S12226 - Telopea Masterplan

TELOPEA RTS 2 S4.55 SCHEDULE OF DESIGN CHANGES

Telopea Masterplan Drawing List

Core & East Precincts - Envelope Control Plan

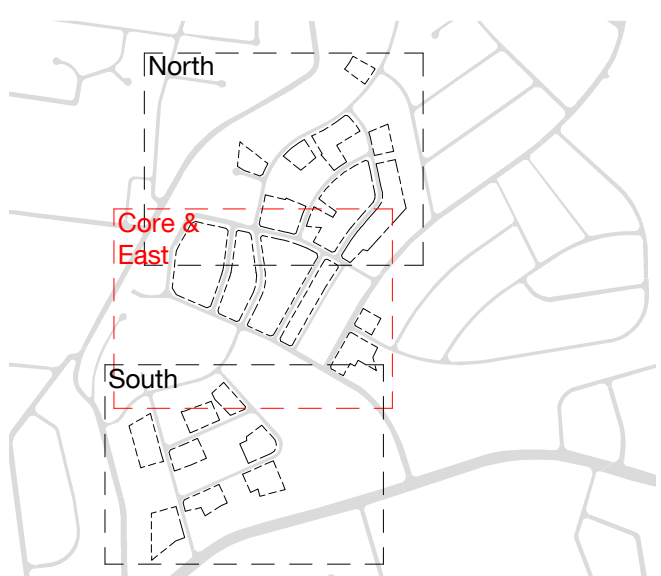
- Envelope Heights increased by 3m to building B
- Core + East Precincts**
 - Envelope heights adjusted to capture increased building heights
 - Lot c1.1 Increased from 70m to 72m

- Lot c1.2 and c2.1 Increased from 86m to 87m
 - Lot c6.1a Increased from 35m to 36m
 - Envelope heights adjusted to capture increased number of levels
 - Lot c5.1c Increased from 24m to 30m

- Lot e1 (Moffats) Increased from 12m to 15m
 - Building breaks (Articulation zones) added to;
 - c1.1, c2.1, c5.1b, c6.1b, c8, e1
 - Building Height increases to recapture lost yield from the precincts

- Building c5.1c increased by two storeys
 - Building e1 Moffats drive wing removed 2-3 storey terraces and replaced with 4 storey apartments
 - Ground level through site links removed from lots c8 and c6.2

Masterplan North Precinct - Envelope Control Plan

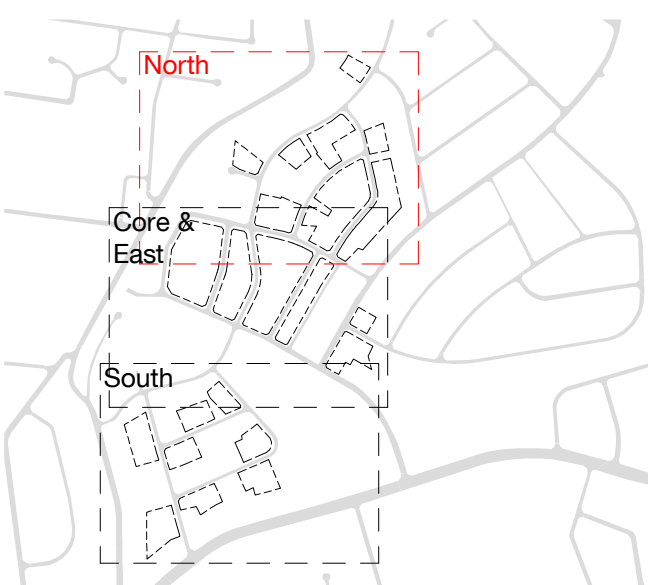
- North Precinct**
 - Street setbacks increased from 3m to 4m
 - Deep soil increased from 25% to 30%
 - Basements setback from streets to maximise deep soil opportunities to street (50% assumed true deep soil)

- Upper level setbacks provided to 8 storey buildings (n3, n5 and n8)
 - Building breaks (Articulation zones) added to;
 - n3, n4, n7.2, n9.1 and n9.2
 - N6.1 redesigned to regain lost yield

- 1x AA1 tree removed
 - Courtyard building with consistent streetwall to Shortland Street (previously stepped around tree)
 - Rear Boundary Setbacks
 - N8, N9, N10 rear boundary setbacks increased from 3- 4m to 6m to maximise amenity to Southern neighbours

- Building Height increases to recapture lost yield from the precincts
 - N6.1 level 7 part-storey, upper level setback
 - N9 rear wings increased from 3 to 4 storeys

- N9 streetwall height increased from 4 to 5 storeys
 - N10 stepped height (4-5 storeys) increased to 5 storeys
 - Ground level through site links removed from lots c8 and c6.2

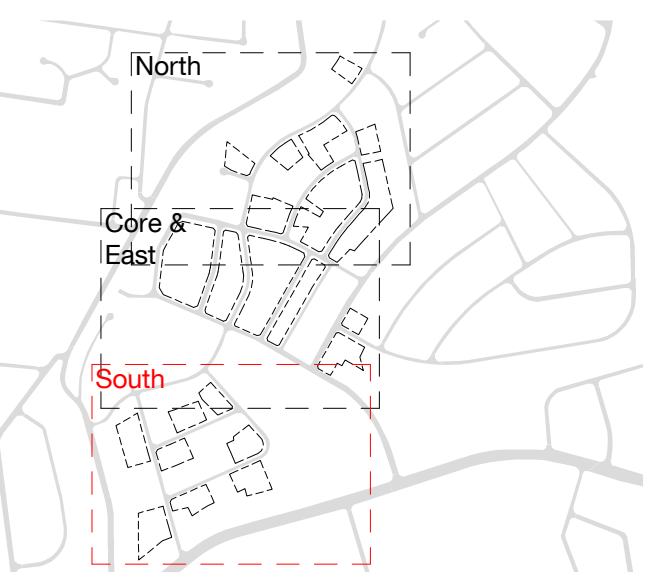
- Building Height increases to recapture lost yield from the precincts
- South Precinct**
 - Street setbacks increased from 3m to 4m
 - Deep soil increased from 25% to 30%

- Basements setback from streets to maximise deep soil opportunities to street (50% assumed true deep soil)
 - Building breaks (Articulation zones) added to;

- s2
 - s3 redesigned to regain lost yield
 - 1x AA1 tree removed
 - Courtyard building with consistent streetwall to Chestnut Avenue (previously stepped around tree)

- 4 storey streetwall to Southern wing with upper level setbacks increased to 5 storey streetwall with upper level setbacks
 - s1 and s2 redesigned to treat 11 Cunningham Street as an isolated lot

- S1 redesigned with 6m boundary setback to 11 Cunningham street
 - S2 redesigned as 21.5m deep building with nil boundary setback to 11 Cunningham Street (to enable future streetwall extension)
